Project No: FX49722

WYP13939/23 - 18-20 & 22 Princes Highway Werribee Further information

As requested, we write on behalf of Princes Wattle Pty Ltd and Princes Gateway Pty Ltd to provide further information about the planning permit application for this land.

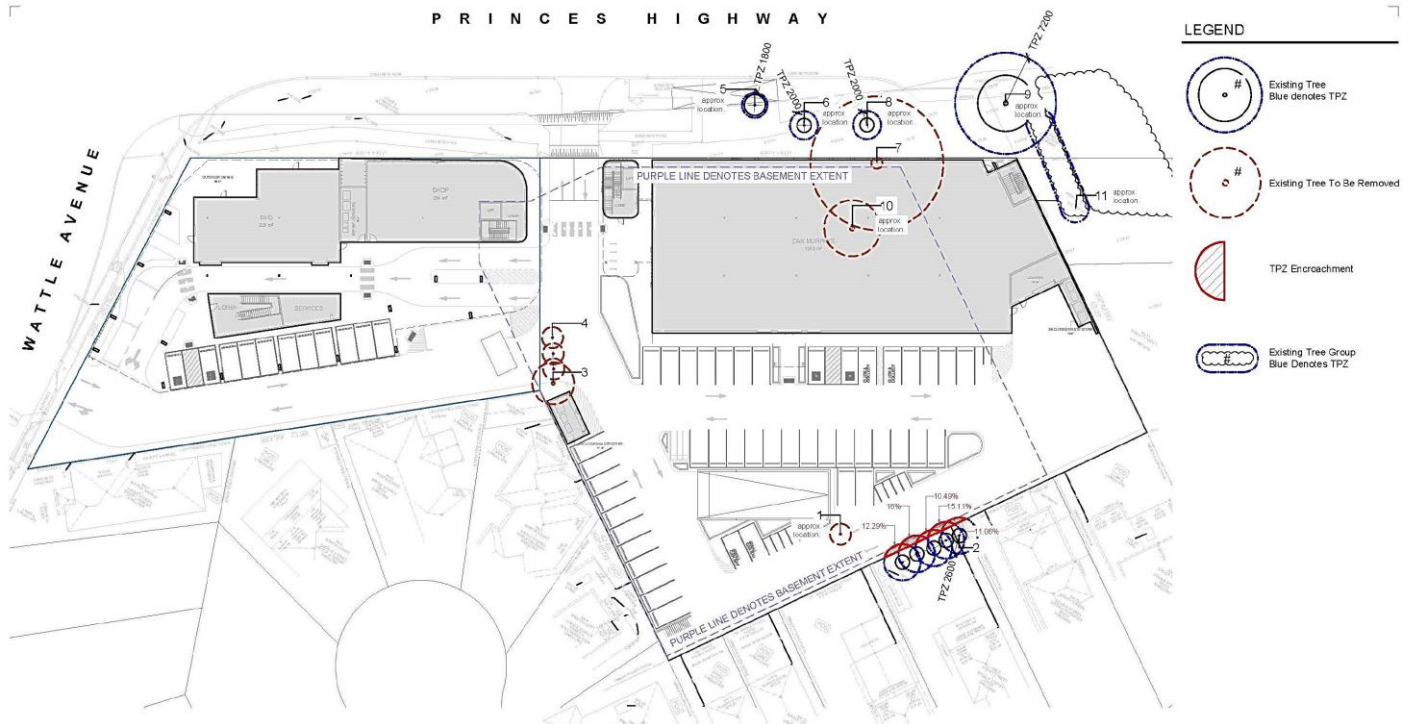
The first sheet of the lighting plan shows the lumen levels across the site, and confirms that there will be no direct spill onto adjacent neighbouring land. The second sheet includes an obtrusive light compliance assessment, which demonstrates that the proposed lighting design meets the requirements of the relevant Australian Standard AS/NZS 4282:2019 *Control of the obtrusive effects of outdoor lighting*.
